## **ADDENDUM NO. 5**

PROJECT:	Saline Area Schools 2015 Bond Program 2017 Projects Phase 1
DESCRIPTION:	Architectural Renovation
BID PACKAGE RELEASE NUMBER:	4
CLARK PROJECT NO:	2714
<b>BID PROPOSAL DUE DATE/TIME:</b>	<b>UNCHANGED</b> <b>11:00 AM, Tuesday, February 7, 2017</b>

**LS-A1.6X**

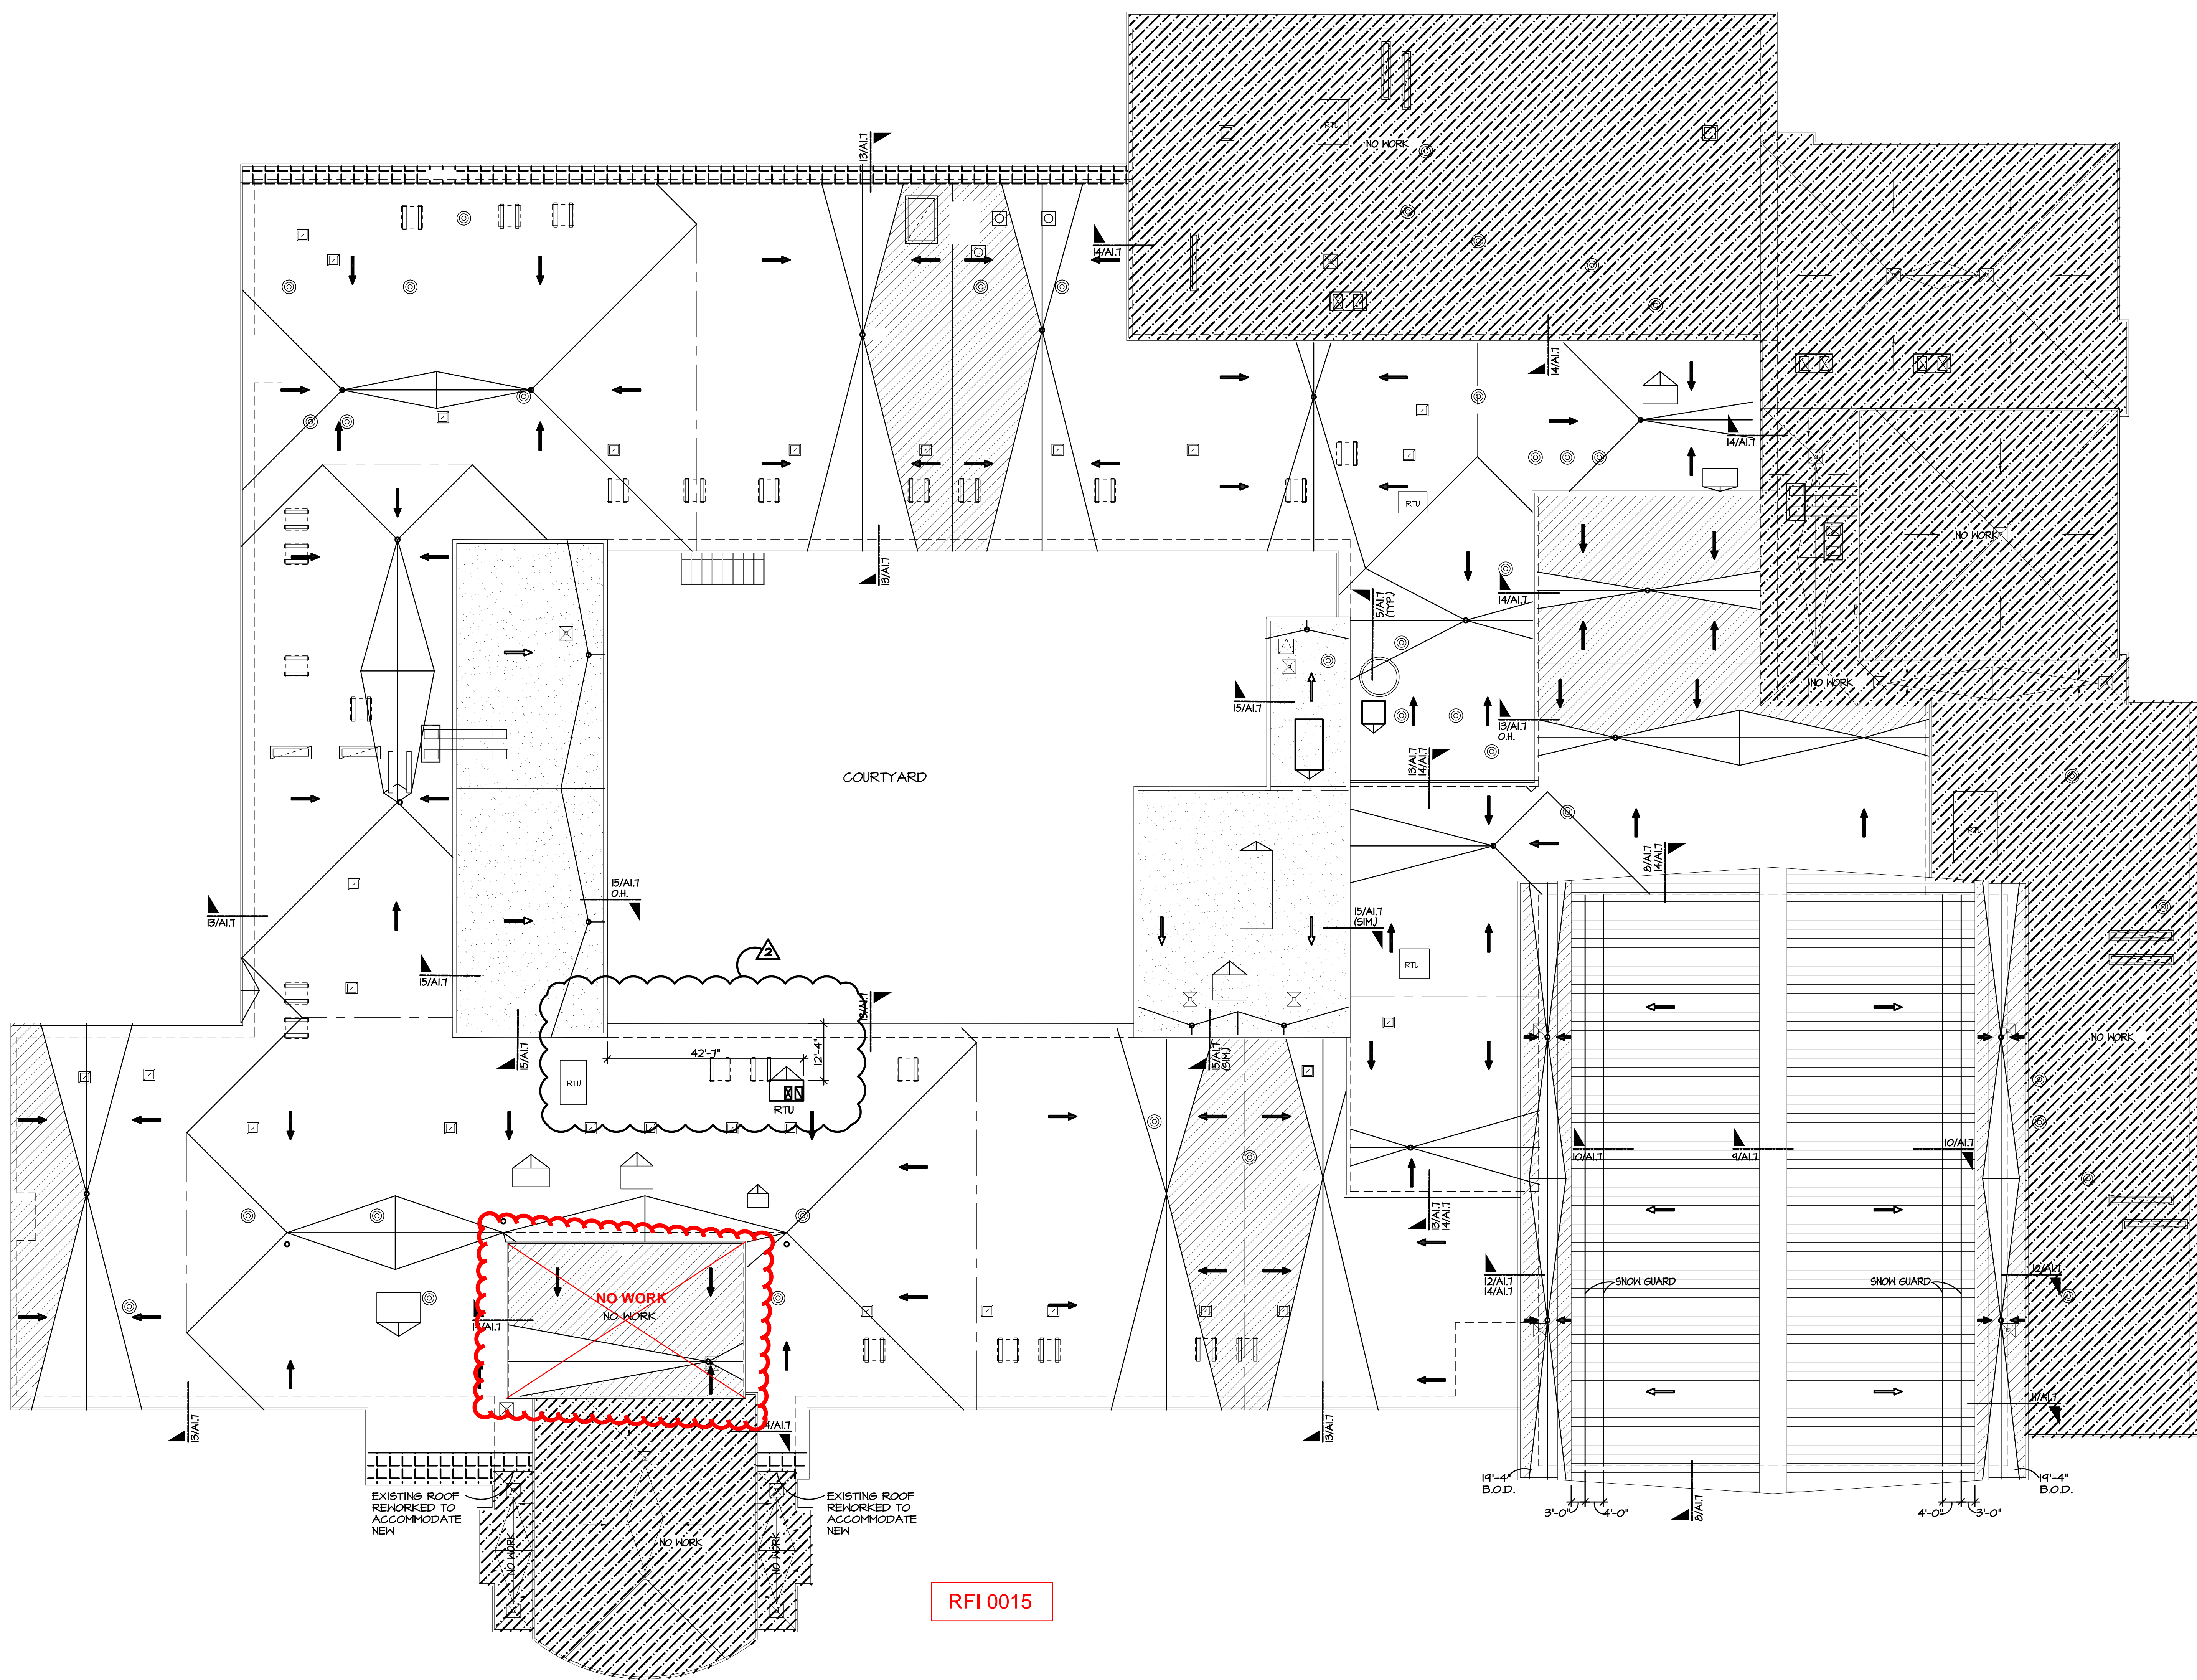
- Q1 Liberty School – The composite roof plan call out an area above the main entrance as no work, however, it is shaded. Please advise.
- A1 See attached LS-A6.1x – Bubbled area in red has no work.
- Q2 Middle School – Architectural demolition drawings area C show two sinks being removed, and show three sinks going back in for new install. Will these be new sinks? If no please provide specification.
- A2 The new sink will connect to existing utilities in the wall and match existing sinks. Provide Elkay BCRA150C sink and faucet or equal.
